Cronus

Release

Notes

Cronus Hardware Release Notes

FIGURE 1. Wire Placement on the Cronus Front Card

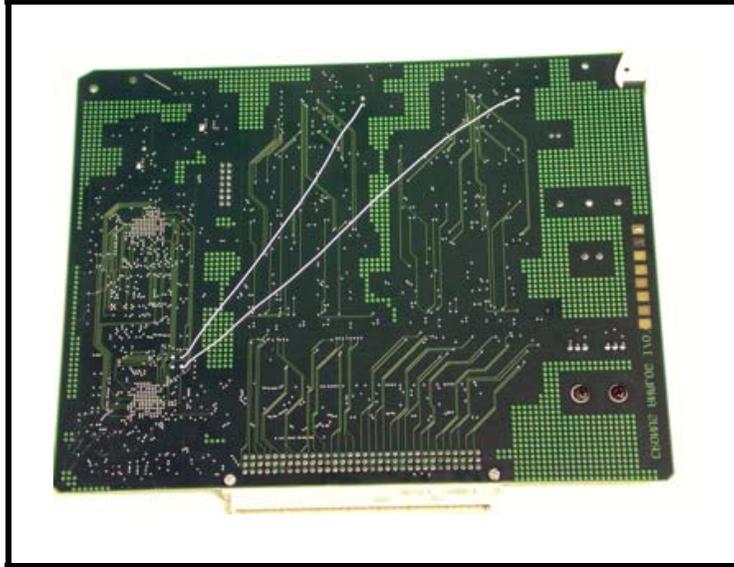
If you currently have the old Cronus AIO board and need to fix the audio distortion from the CODECs being asynchronous, do the following:

1. Identify test points TP4, TP18, TP19, and TP28 on the front side of the board.
2. Turn the board over to the backside.
3. Using Kynar type jumper wire, connect TP4 to TP18 and TP28 to TP19.
4. Turn the board over to the front side.

5. Using an ohm meter, check for continuity between TP4 and TP18 and continuity between TP28 and TP19.

FIGURE 2. Resistors and capacitors that need to change to upgrade the gain amount.

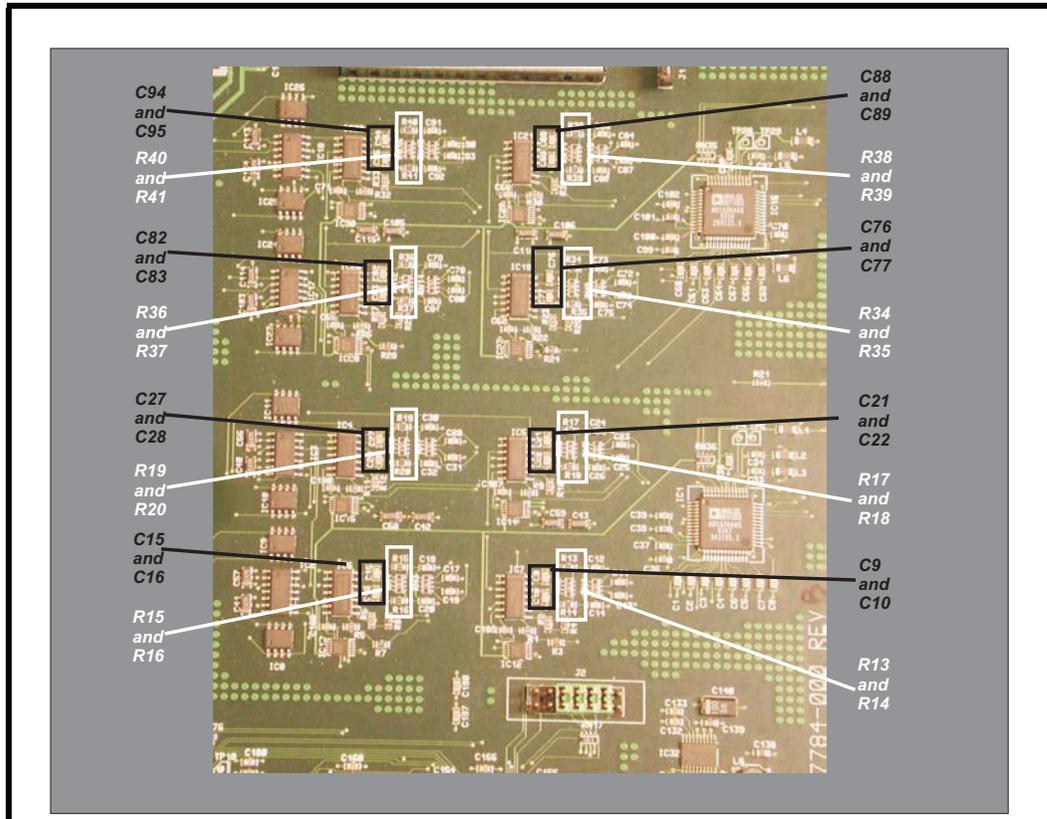
1. On the front card, replace the following 16 resistors with a 220k resistor (part number 102506-224)

The resistors that change are the following:

R13, R14, R15, R16, R17, R18, R19, R20, R34, R35, R36, R37, R38, R39, R40, R41

3. On the front card, replace the following 16 capacitors with 12pF capacitor (part number 723411-14). See figure 2.

The capacitors that change are the following:

C9, C10, C15, C16, C21, C22, C27, C28, C76, C77, C82, C83, C88, C89, C94, C95.

FIGURE 3. TP7 Ground to J3 C1 connector placement

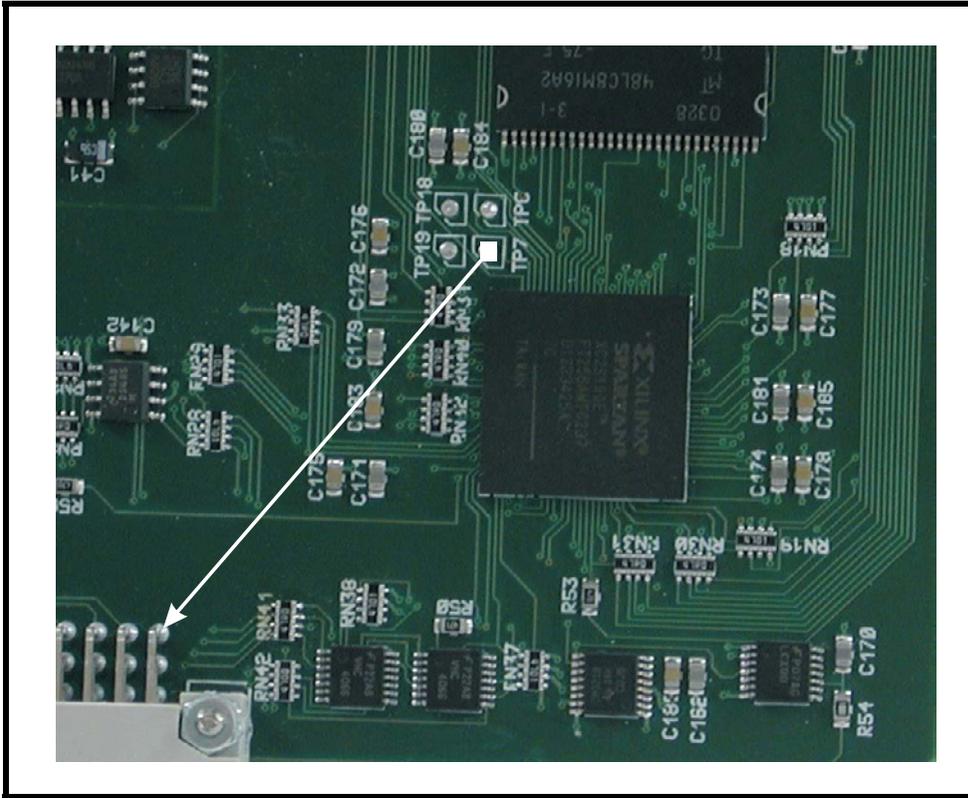
2. On the front card, ground TP7 to connector J3 pin C1 so it will be recognized as the new Rev D card. See figure 3.

FIGURE 4. New AIO board capacitor placement

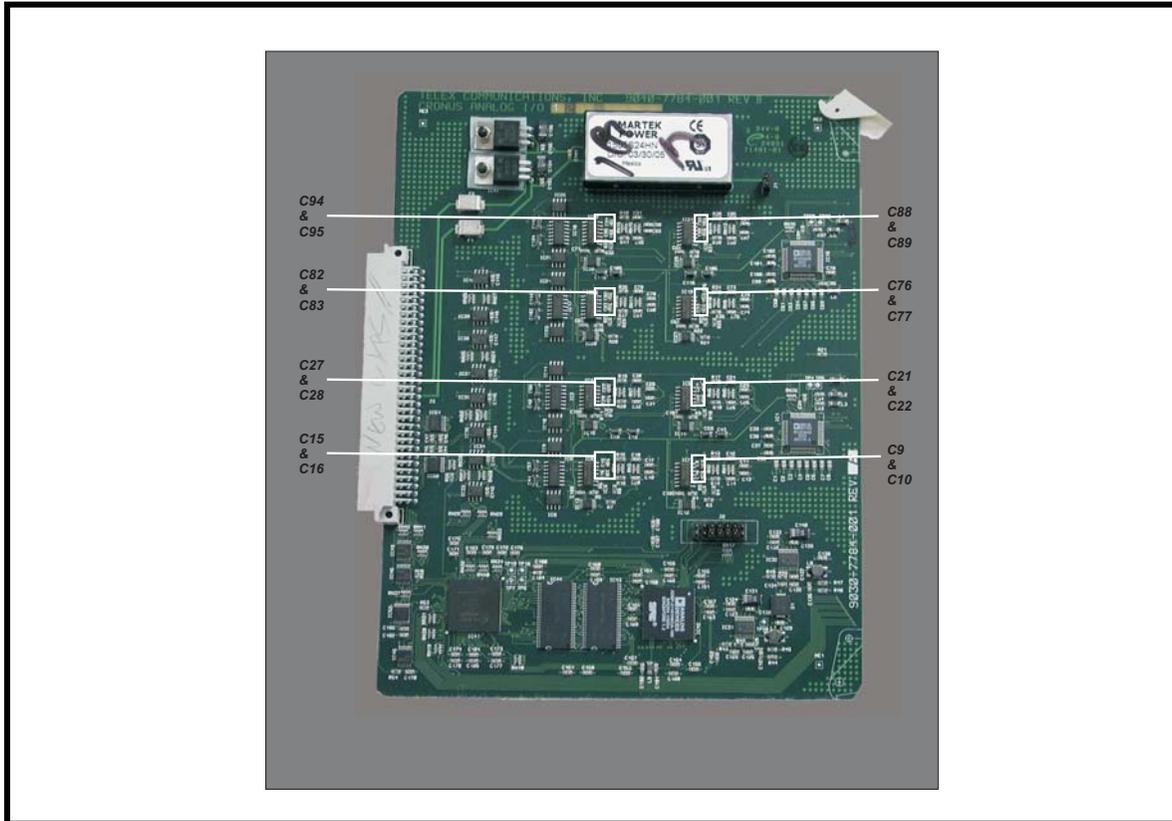
It was noticed that the frequency response starts dropping at 10KHz instead of 20KHz as specified in the User Manual.

To fix the Frequency Response problem, an EC #13-000341 was issued to replace 16 capacitors from 100pF to 12pF (part number 723411-14)

The 16 affected parts are C9, C10, C15, C16, C21, C22, C27, C28, C76, C77, C82, C83, C88, C89, C94 and C95.

The modified AIO front card should have the reference markup changed from 9030-7787-001 Rev B to Rev C. See figure 4.

FIGURE 5. Capacitors on the RJ 12 (A) rear card and the MDR (B) rear card.

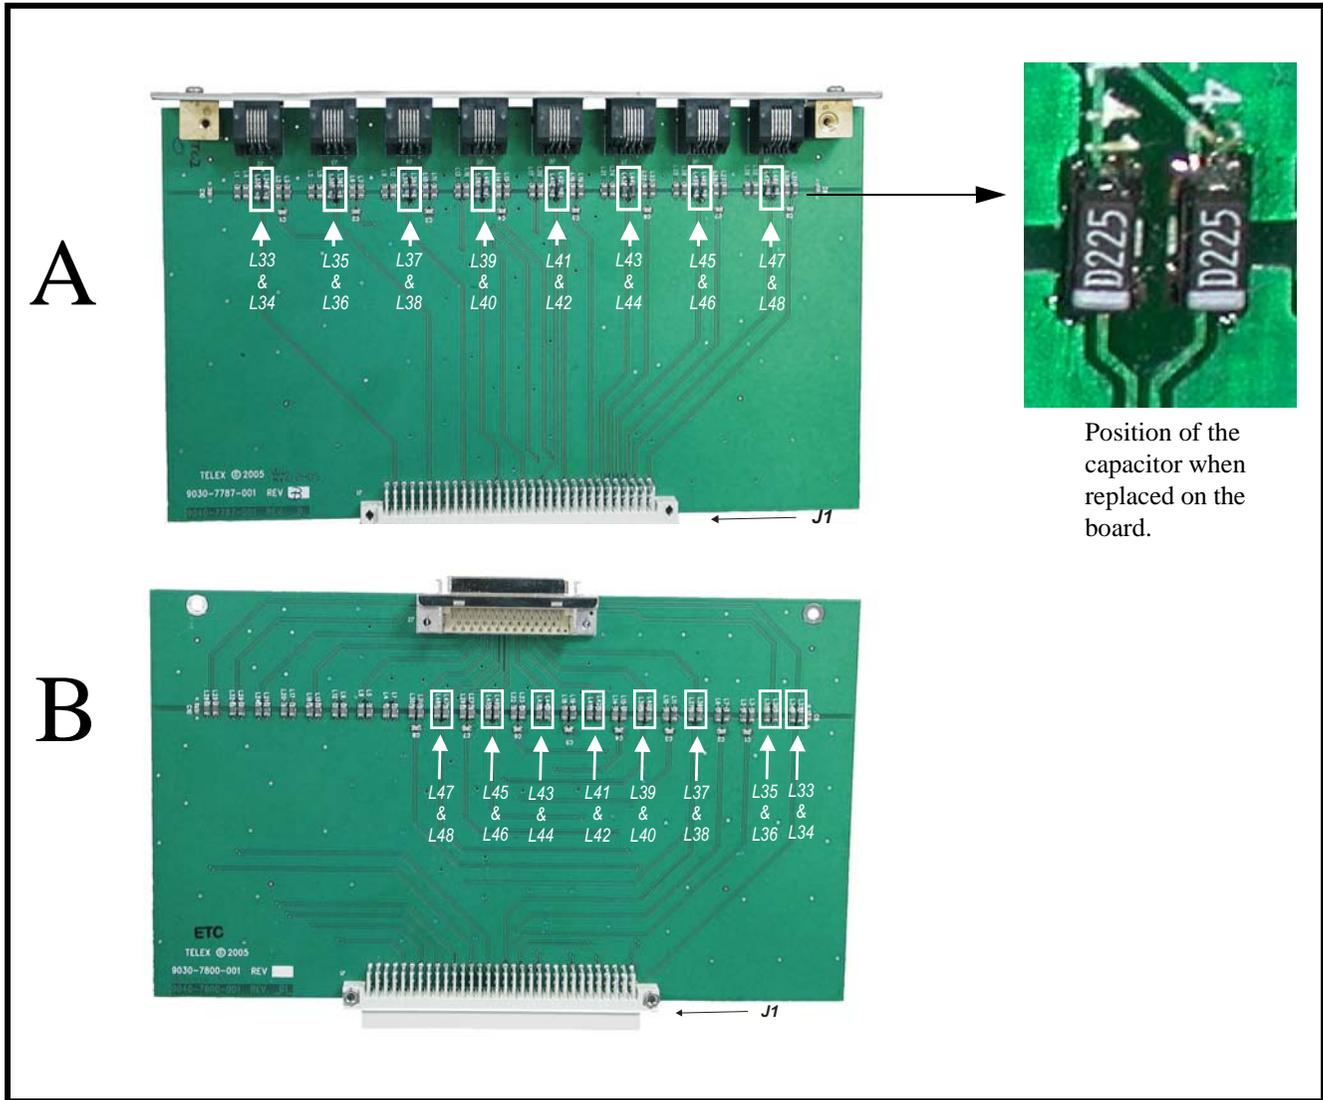
After changing the design to have an option for analog output gain up to +20dB, the AIO card (9030-7784-001) has exhibited DC bias voltage on the audio output differential pairs of +/- 1.8V.

To fix the DC Bias problem, two ECs were issued to replace the ferrite beads on the audio outputs of the AIO rear cards with DC blocking caps (4.7 uF/16V), part number 102877-070.

EC 46-000351 changes the RJ12 AIO rear card from 9030-7787-001 Rev B to Rev C (See reference A below).

EC 46-000361 changes the MDR Rear Card from 9030-7800-001 Rev A to Rev B (See reference B below).

The 16 affected parts are L33, L34, L35, L36, L37, L38, L39, L40, L41, L42, L43, L44, L45, L46, L47, L48.

IMPORTANT: The positive end of the capacitor should point toward J1 connector (see inset of figure above).

FIGURE 6. Resistor Changes on RVON-I/O (9030-7772-000)

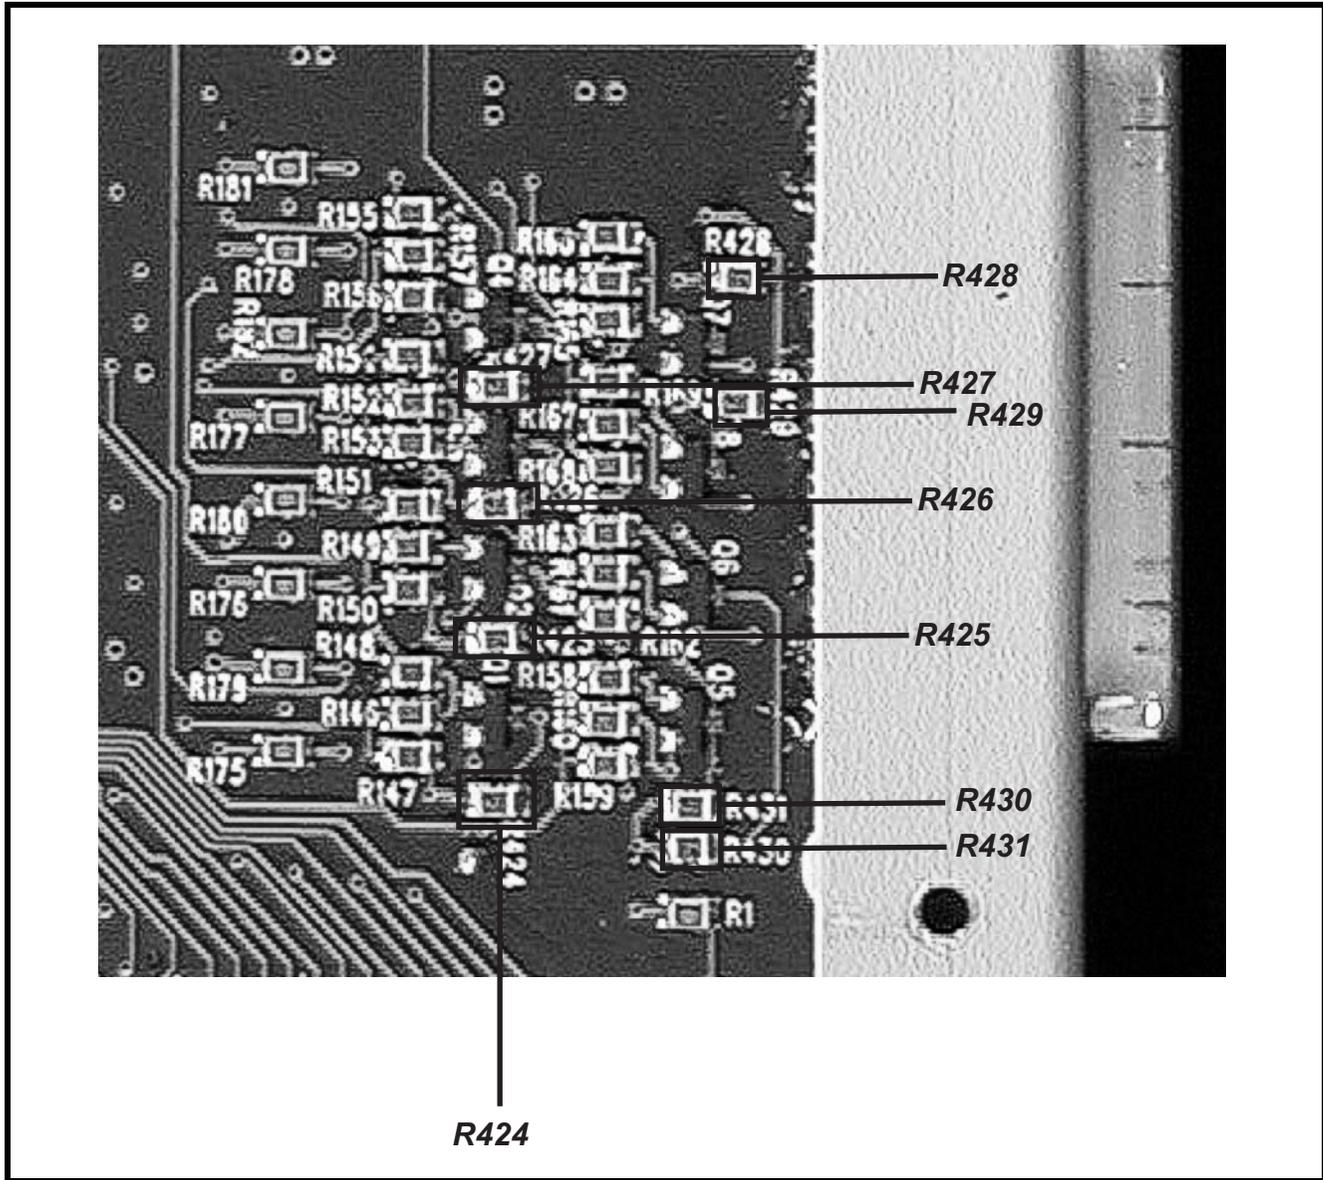
The RVON-I/O's voltage drop across the GPO Output resistor is too large for the Cronus photo coupler GPI. The Cronus series resistor to the photo-coupler is also too large. The voltage drops across both resistors prohibit operation.

To fix this issue, change the RVON-I/O GPO Output from 22.1K to 6.19K on the RVON-I/O card and replace four resistors (R11 through R14) from 3 K to 470 Ohms.

1. On the RVON-I/O card remove 8 resistors (R24 through R431) and replace with 6.19 K resistors (part number 102515-276). See Figure 1 for resistor placement.

FIGURE 7. Cronus board resistor placement (9030-7788-001)

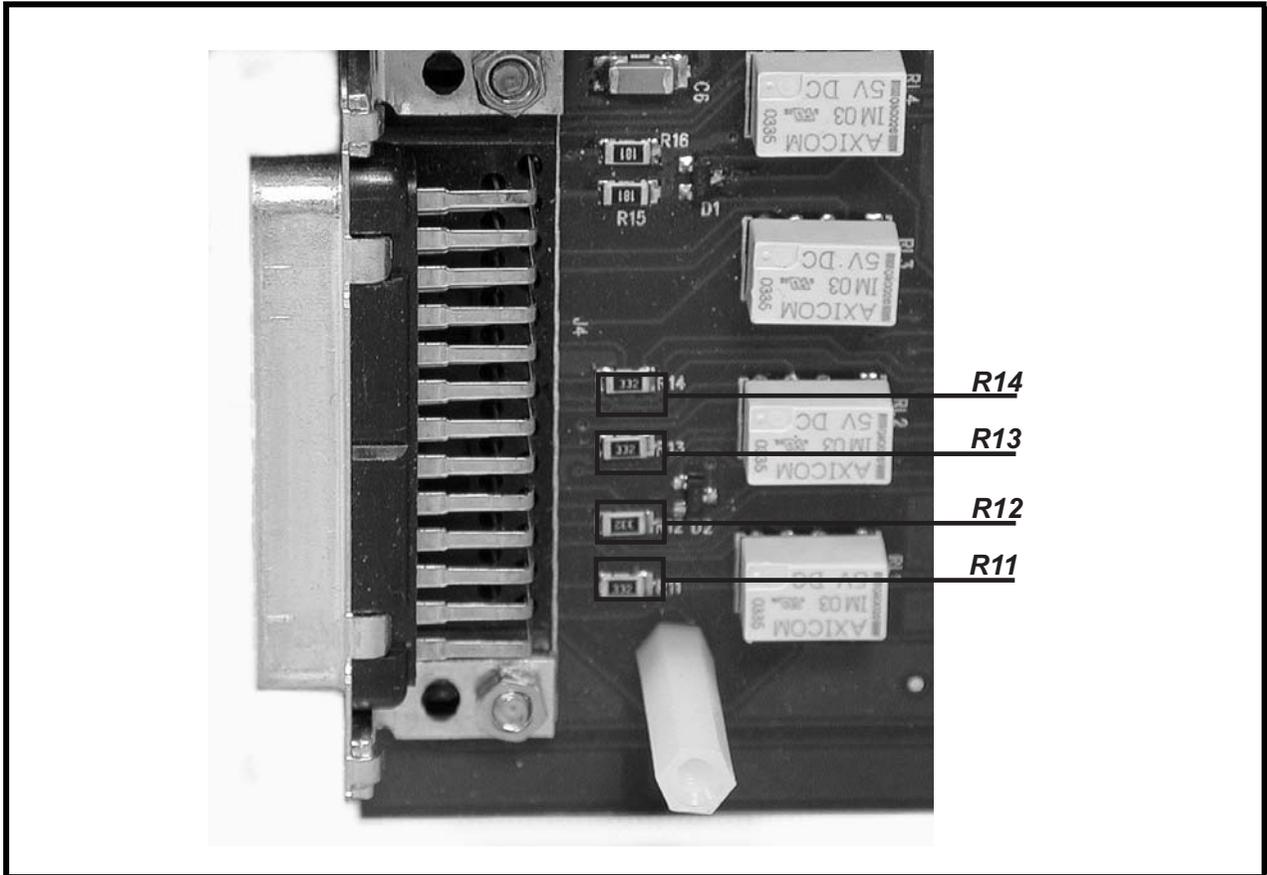
NOTE: The Cronus Master Controller backcard will go from **9030-7788-001 Rev A** to **9030-7788-001 Rev B**.

2. On the Cronus MC Back card, remove the 3K resistors (R11 through R14).
3. Replace the resistors with 470 Ohm resistors (part number 102513-471).
